Proposed works at Walkerville Retarding Basin

Promontory Views Estate Retarding Basin
Walkerville

Report by Independent Expert

30th April 2018

RETAINING BASIN INLET AND OUTLET STRUCTURES
Scale 1:100

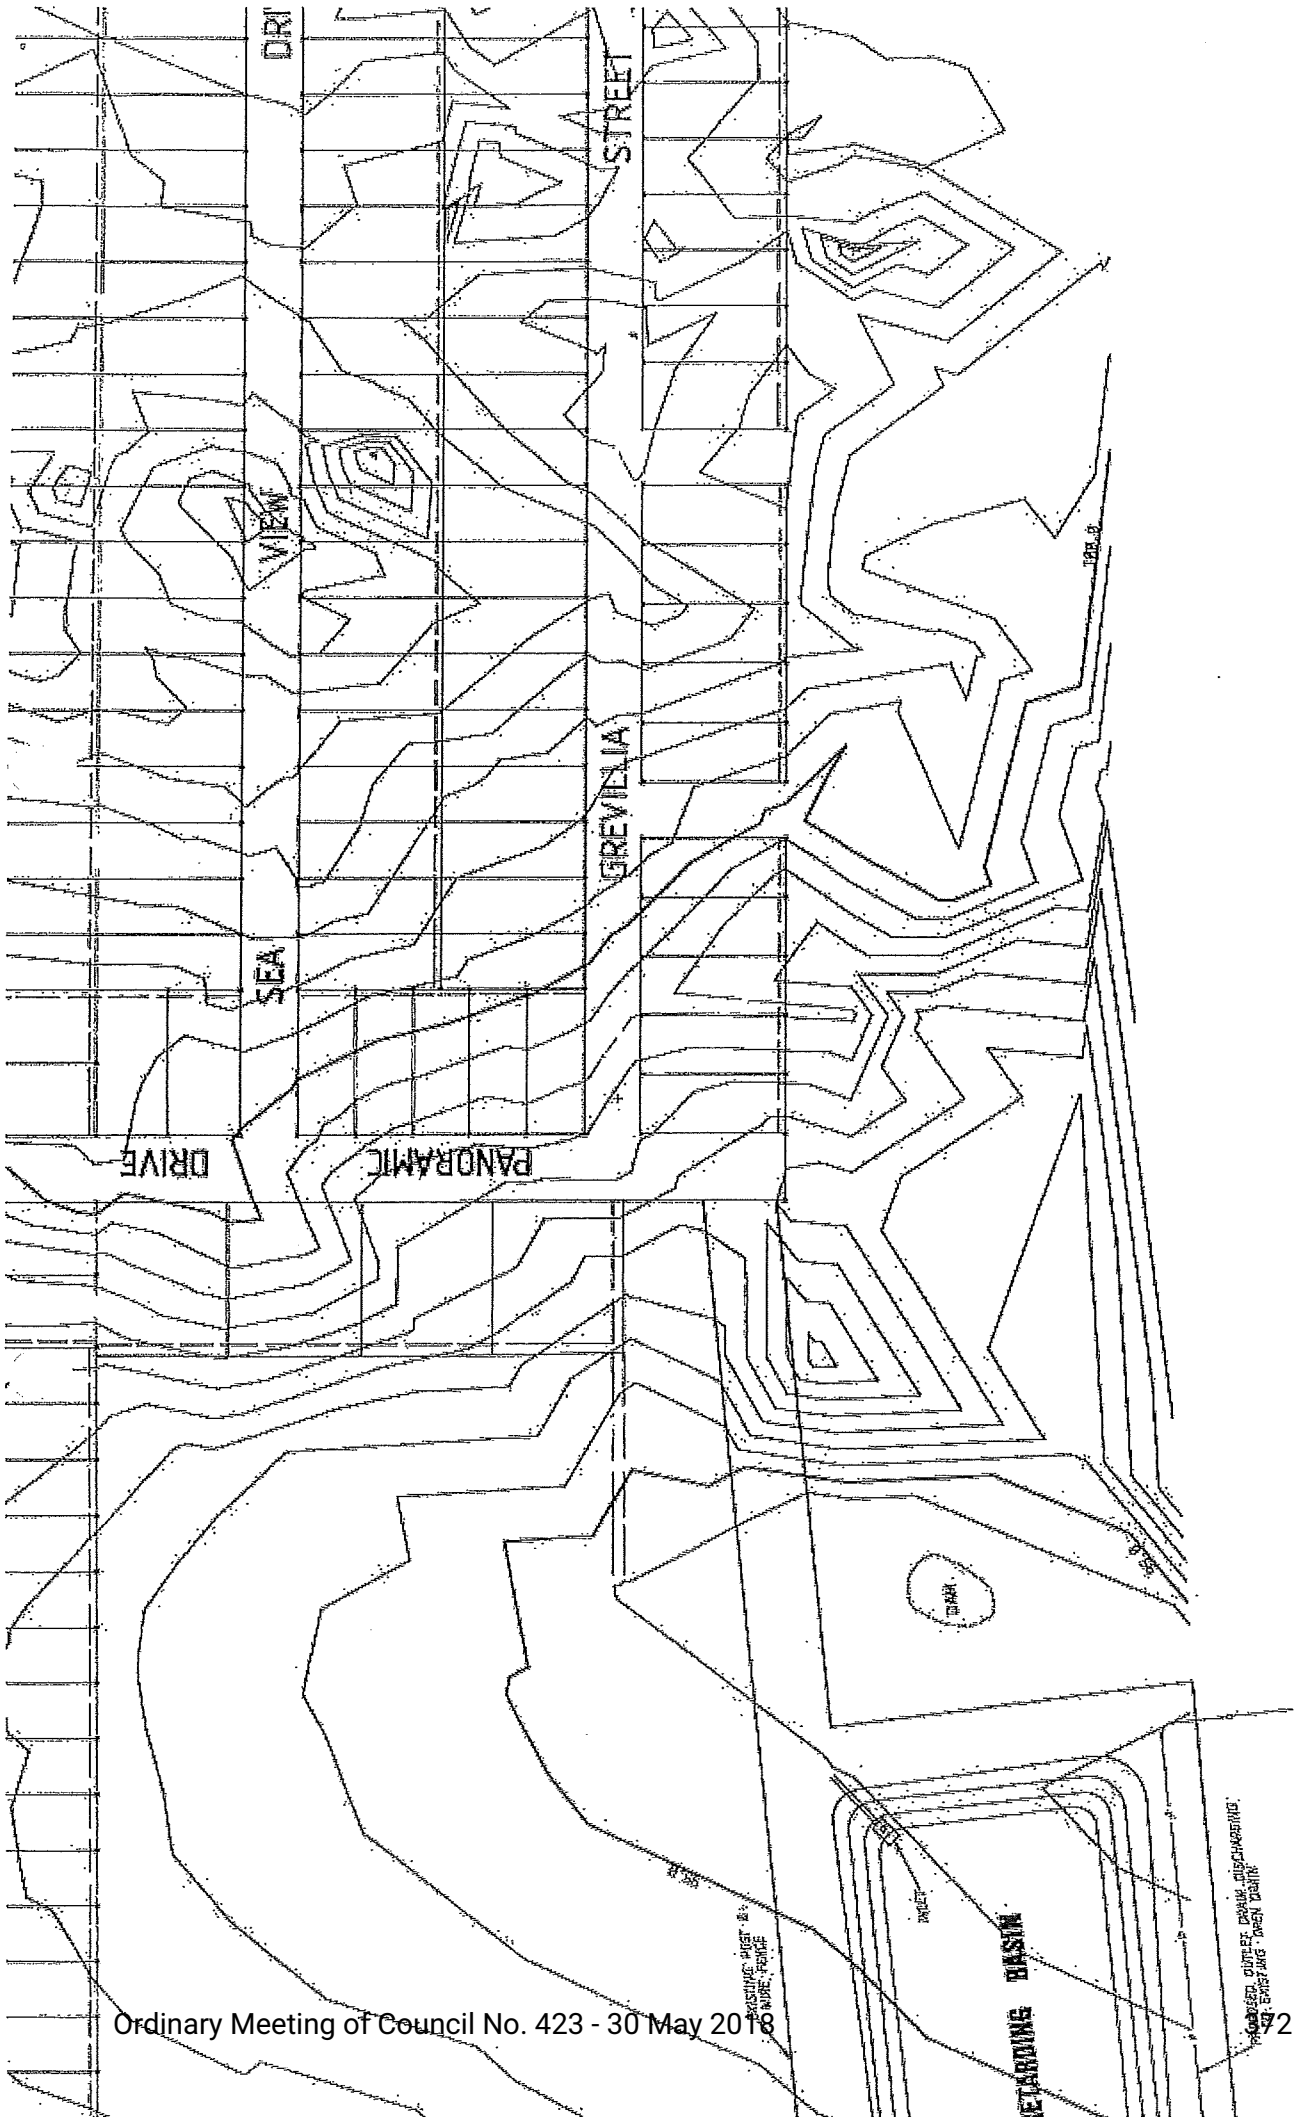
The drawings also show the detail of the inlet and outlet structure arrangements (plan 16 of 16). The invert level of the inlet pipe is specified on plan 8 of 16 as RL 94.5 m, equal to the design floor level indicated for the basin.

The invert level of the outlet pipe is not specified on the drawings but is drawn at the base of the outlet pit which is shown to have dimensions of 0.75 m by 0.9 m. I believe that this intends to refer to a pit 0.75 m square and 0.9 m deep, because the steel grating cover to the pit is shown as “1x 0.8m”, which I believe indicates a cover 0.8 m square. The drawing also indicates “2 No. 0.4 x 0.4 m square inlet ports”. There is no indication of the proposed invert level of these ports, which would determine FSL and consequently storage volume.

SOUTH GIPPSLAND SHIRE COUNCIL
PROMONTORY VIEWS BASIN WORKS
PANORAMIC DRIVE, WALKERVILLE
 LAYOUT PLAN

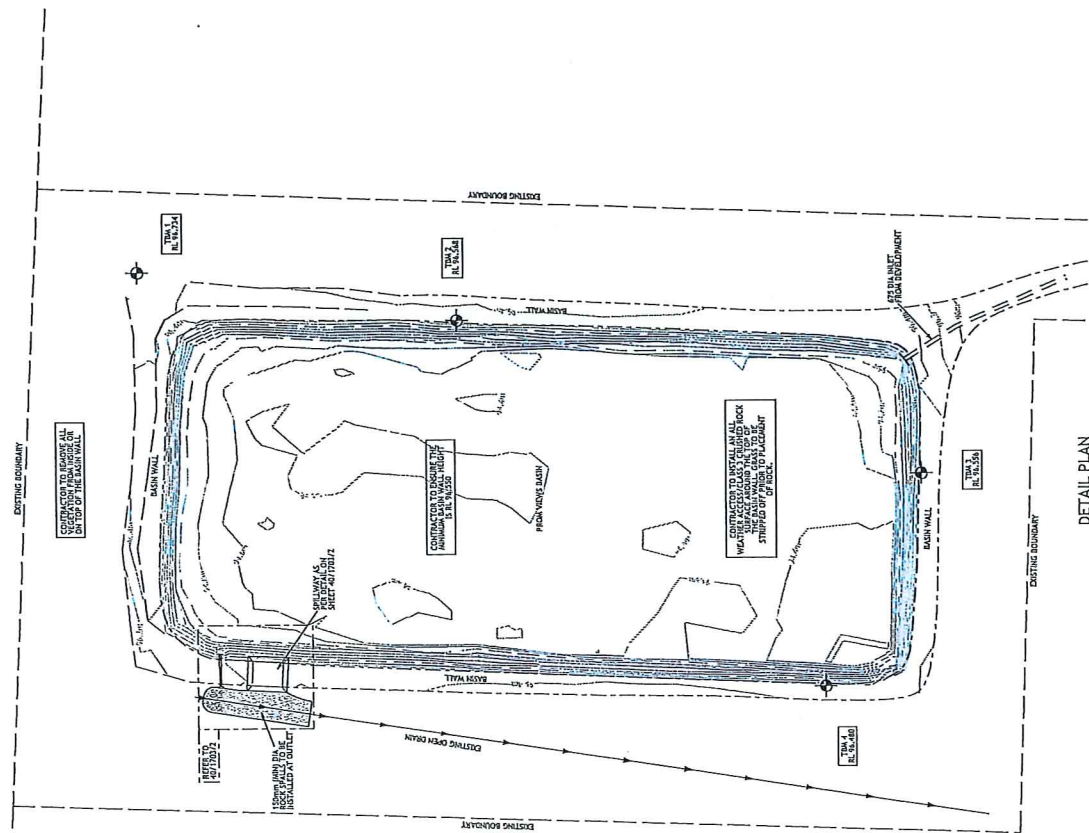
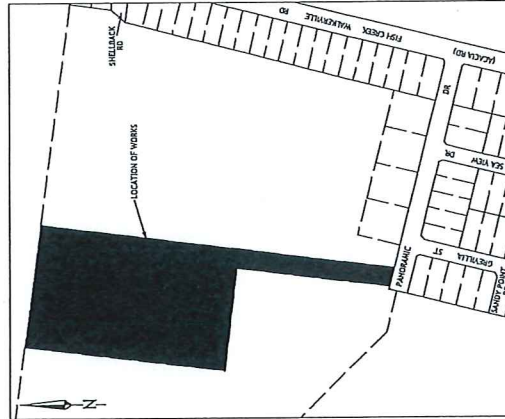
- (iii) The outlet works are to be modified by the removal and reconstruction of the top of the outlet pit including a new overflow level of RL 96.160 m with the existing pipe to be removed and replaced with *“375 dia RCP RRR existing levels.”* I understand this to indicate a 375mm diameter rubber ring jointed reinforced concrete pipe.

SOUTH GIPPSLAND SHIRE COUNCIL
 PROMONTORY VIEWS BASIN WORKS
 PANORAMIC DRIVE, WALKERVILLE
 DETAIL PLAN AND SECTIONS

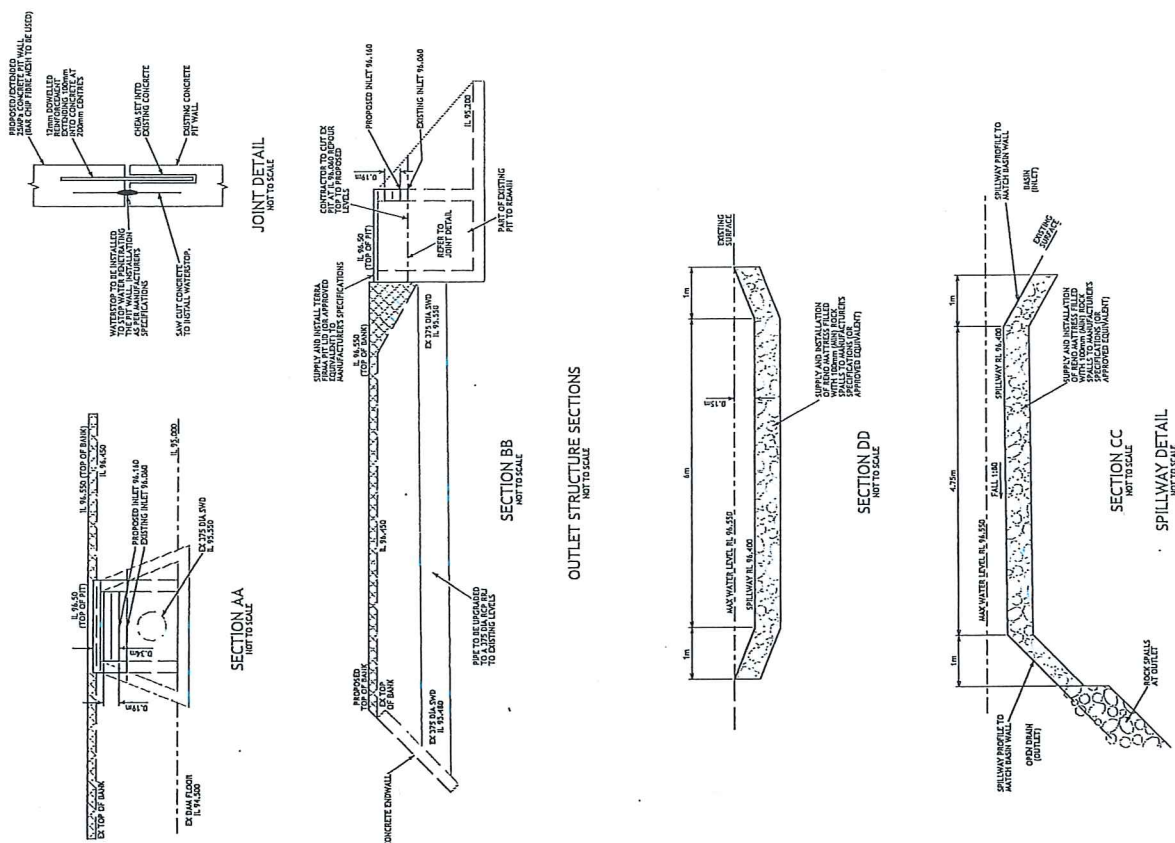
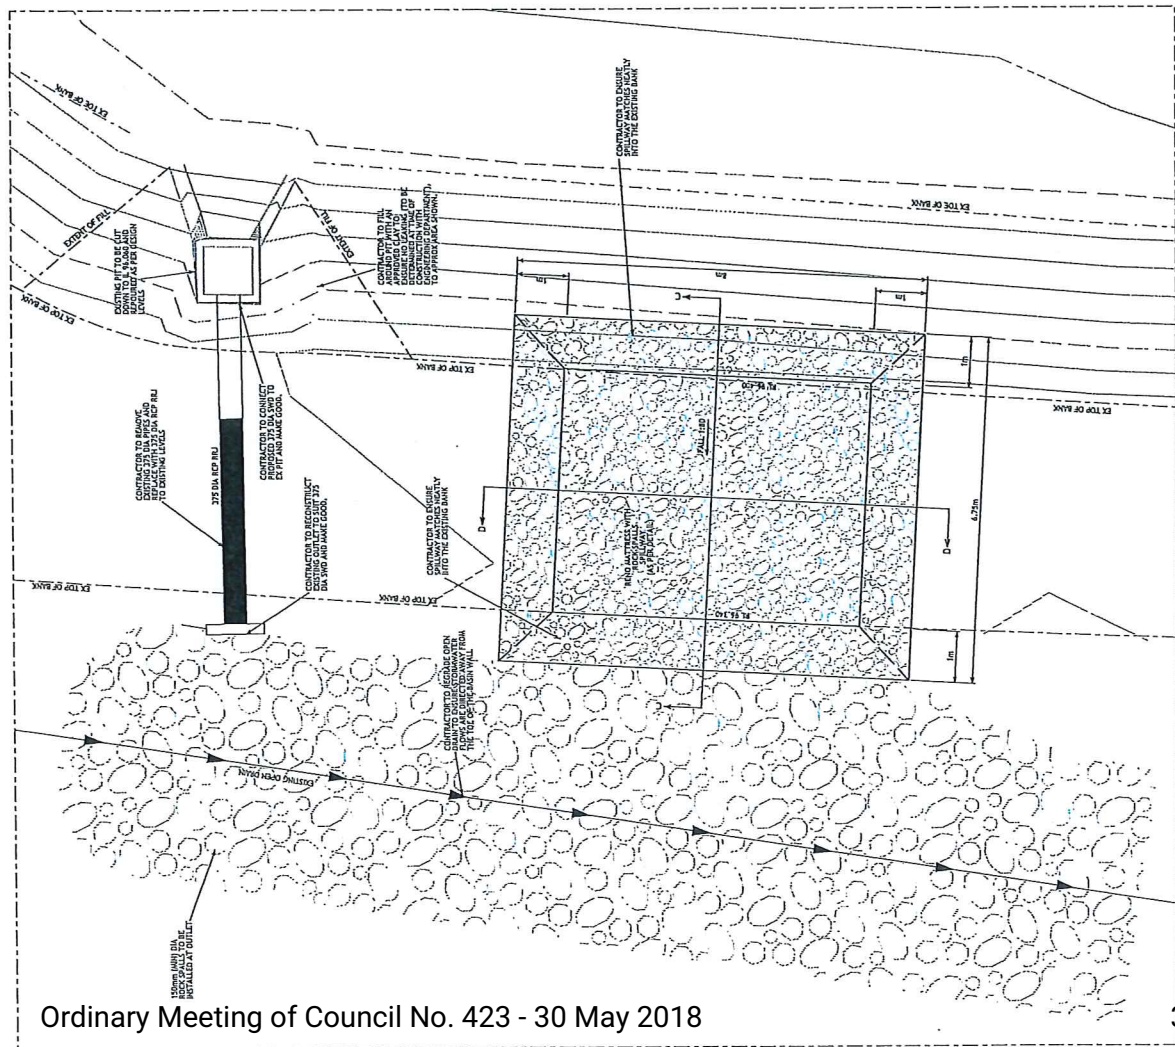
- (i) The extent of the vegetation removal is apparently limited to the *“inside and top of the basin wall”*. Sound dams engineering practice is to remove all woody vegetation (generally trees, bushes and shrubs) and to maintain all faces of earthfill embankments, including the downstream face, free of any vegetation other than grass and similarly cleared away from the downstream toe such that tree roots cannot interfere with the embankment or its foundations.

- (ii) SGSC’s proposal to replace/reconstruct the outlet pipeline is generally supported, however the primary issue is to ensure that any existing damage, softening or erosion of the dam embankment in this area due to seepage along the existing pipe is properly remediated and prevented from occurring in the future. This may require excavation of affected areas of the embankment and replacement with properly sourced and compacted fill materials. This issue is not specifically addressed in the proposed works. The drawings shade the outlet pipe from just upstream of the dam crest centreline to the downstream end of the outlet. It is unclear as to what this shading represents but it could be interpreted to mean only a partial replacement and treatment of the outlet, which, on the available information, I do not consider to be sound practice.

- (iii) The placement of a crushed rock capping over the crest of the dam is supported, provided that it is suitably designed to ensure that any potential for excessive drying and cracking of the embankment fill, or the ponding of surface water leading to ingress into the earthfill, is minimised. There is no detail provided of the embankment treatment prior to the placement of this crushed rock material other than *“grass to be stripped”*.

The 150mm deep longitudinal cracking noted during my inspection may indicate the presence of a 150mm depth of topsoil on the existing dam and if so, sound practice would be to remove this topsoil prior to rock placement. In any case the extent and causes of this cracking should be understood before any proposal to raise the dam FSL, because cracking in the top of an earthfill dam embankment can lead to seepage, internal erosion of embankment materials and potential dam failure.

I have seen no design details for this spillway in relation to its discharge capacity or likely frequency of operation, which is usual practice when designing a spillway for a dam. The design and construction detail for the downstream side of the spillway where it discharges over the downstream face of the dam and toe are unclear but very important to ensure no erosion of the embankment will occur during spillway operation.

- (v) It would be sound engineering practice for a Dams Engineer to provide a clearly documented specification for any significant modification to a dam, involving reconstruction of an outlet, construction of a new spillway and reconstruction of the embankment and permanently raising FSL. The purpose of such a specification is to ensure that the Dams Engineer's design is properly interpreted by the construction contractor to enable the works to be delivered to the required standard, including use of appropriate materials and placement techniques. I have not seen any evidence that such a construction specification exists for the proposed works.
